**CULTURAL RESOURCES OFFICE
 PRESERVATION BOARD
 REGULAR MEETING
 MONDAY - FEBRUARY 23, 2015 — 4:00 P.M.
 1520 MARKET ST. #2000
 ST. LOUIS, MO. 63103
www.stlouis-mo.gov/cultural-resources**

DATE: February 23, 2015
 ADDRESS: 5766 Pershing Avenue
 ITEM: Preliminary Review: Construction of a single-family house
 JURISDICTION: Skinker-DeBaliviere Catlin-Tract Certified Local Historic District — Ward 28
 STAFF: Bob Bettis, Cultural Resources Office

DATE: February 23, 2015
 ADDRESS: 4942-44 McPherson Avenue
 ITEM: Appeal of Director’s Denial to retain wrapping on window brickmolds and sills
 JURISDICTION: Central West End Local Historic District — Ward 28
 STAFF: Bob Bettis, Preservation Planner, Cultural Resources Office

DATE: February 23, 2015
ADDRESS: 2215-17 Indiana Avenue
ITEM: Appeal of Director's Denial to install fourteen vinyl windows and retain a non-compliant front door on the Public Façade
JURISDICTION: McKinley Heights Local Historic District — Ward 7
STAFF: Bob Bettis, Preservation Planner, Cultural Resources Office

SITE PLAN

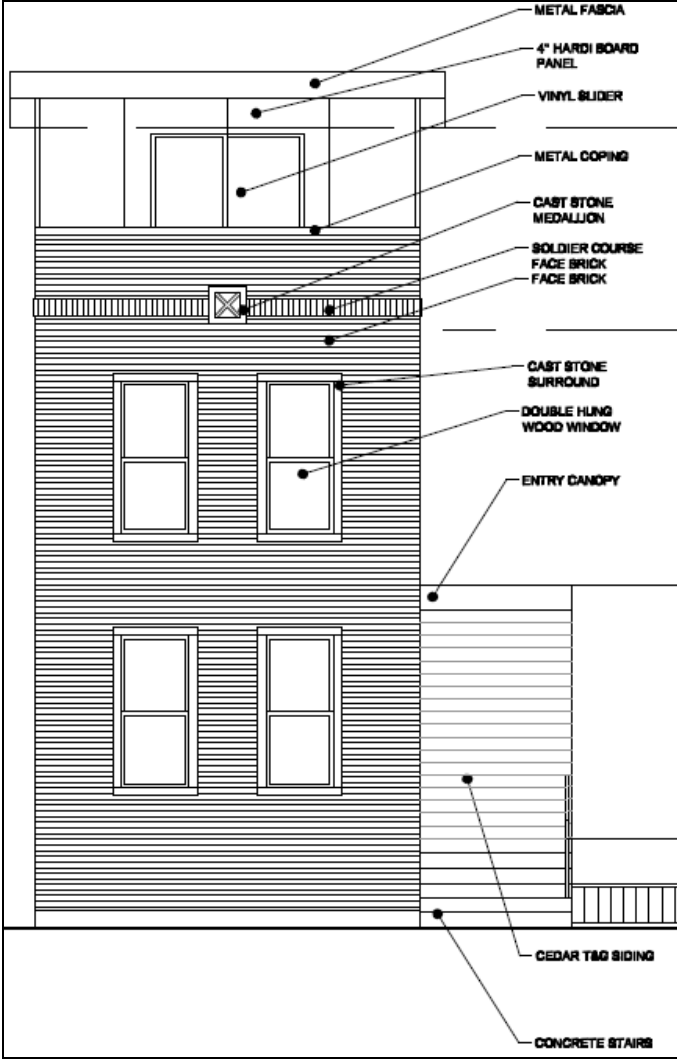
Complies. The proposed setback is in line with the adjacent buildings.

FRONT (NORTH) FAÇADE

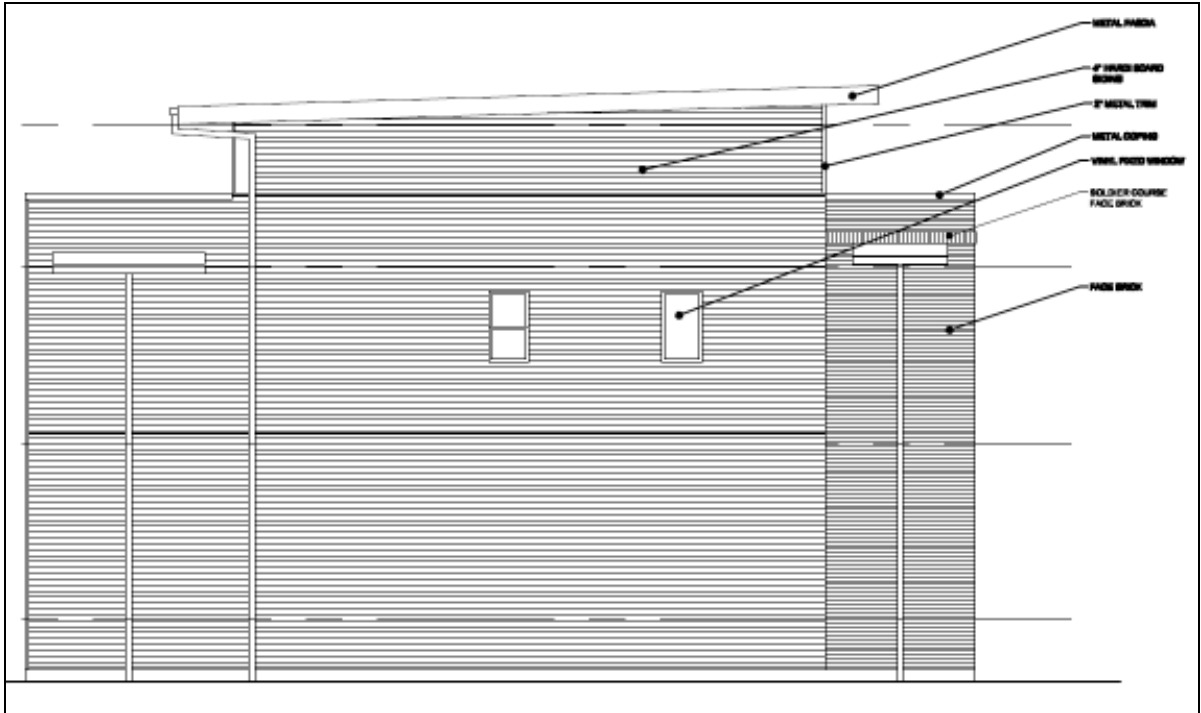
Partially complies. The proposed building will have a brick veneer on most of the façade that extends onto the front portions of the side walls. The rest of the building will be clad with Hardie Board siding painted to match the brick veneer. Cedar siding with a clear finish will face the wall sheltering the main entrance. Cast concrete units will trim the front windows.

Complies. Proposed building floor heights, window proportions, scale and materials are compatible with the adjacent buildings.

SOUTH FAÇADE

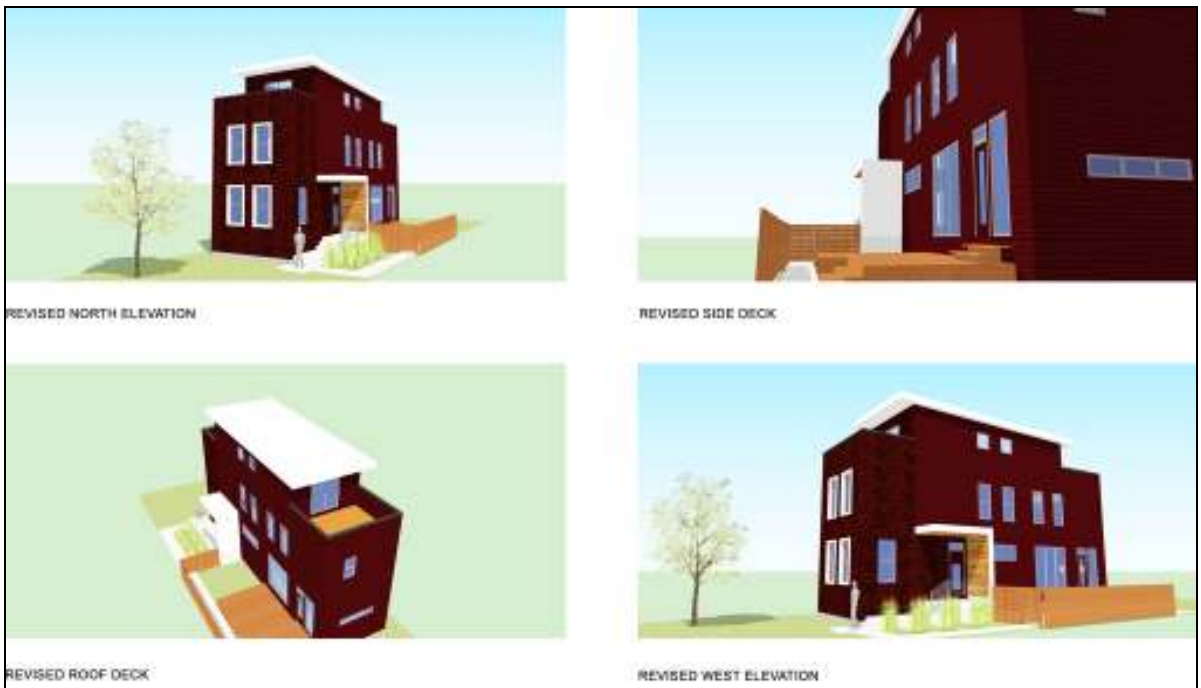
Complies. There are a number of different roof types on the block. The selected flat roof is compatible with the surrounding structures.

Complies. The roof is flat and not street visible.
